ADDENDUM

SOLICITATION NO.: RFP 2018-11 – City of Parkland Library Expansion

ADDENDUM NO. 1

DATE: 05/01/18

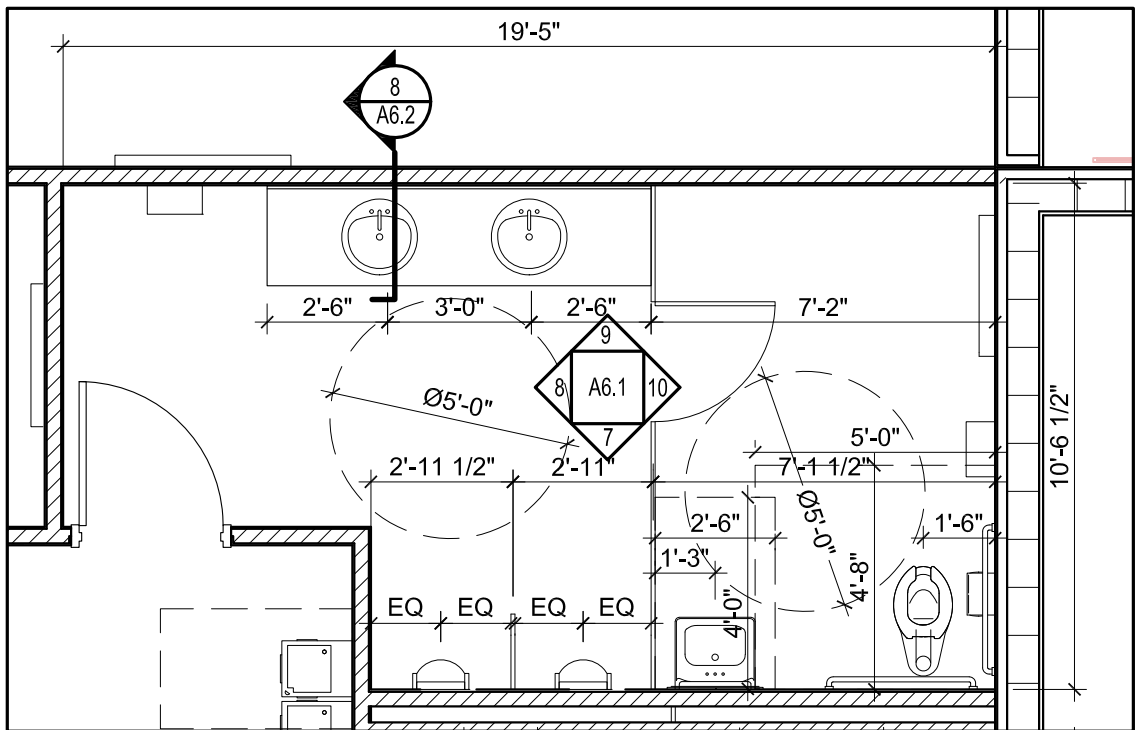
- **All HM door frames to be 16-gauge.**
- **ADA restroom stall dimension to be as shown on the modification attached SK-1 dated 4/30/2018.**
